**BEFORE THE DISTRICT OF COLUMBIA
BOARD OF ZONING ADJUSTMENT**

**APPEAL OF ANC 1C &
MICHAEL G. RAFFERTY
REGARDING 1828 ONTARIO PLACE, N.W.**

APPEAL NO. 19081

PRE-HEARING STATEMENT OF THE APPELLANTS

Plat for Building Permit of SQUARE 2583 LOT 438

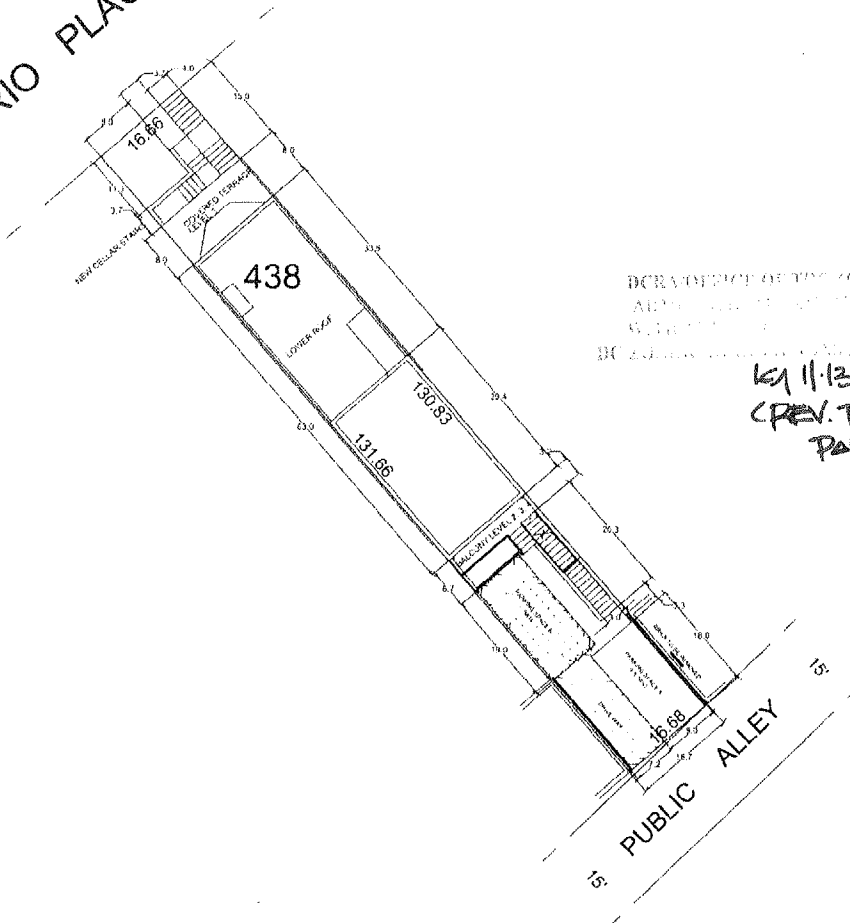
In addition, it is clear from a review of the Building Plat dated 11/12/2015 filed by the Property Owner with the PIVs, which is attached as a part of Appellants' Exhibit C, that the parking space located immediately off the public alley partially obstructs full access to the more interior space accessed from the "drive aisle" (**See Appellants' Exhibit C - Property Owner's Revised Property Survey – Filed by Motion November 13, 2015 and Used as the Basis for the Revised Building Permit**).james

1 PROPOSED PARKING
SCALE: 3/16" = 1'-0" 24X36 LAYOUT

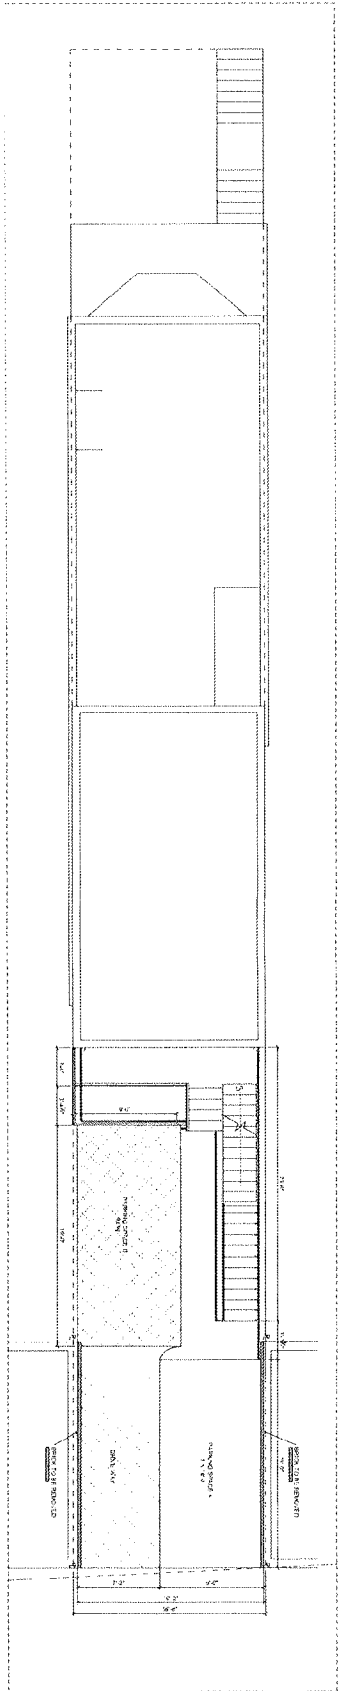
- **Proposed Parking Solution.** The proposed parking layout in the Revised Building Permit requires a minimum 16'2" opening since it provides for both a driveway with a minimum width of 7' required pursuant to Section 2117.8(b) (7'2" wide on plans) along-side a parking space (9' wide) (*See Appellants' Exhibit C - Property Owner's Revised Property Survey – Filed by Motion November 13, 2015 and Used as the Basis for the Revised Building Permit*). The 7'2" driveway plus the 9' parking spot equals 16'2", or 7" wider than the 15'7" opening available at the alley and the maximum width available to the Property Owner is 5" narrower than the absolute minimum required under the Zoning Regulations.
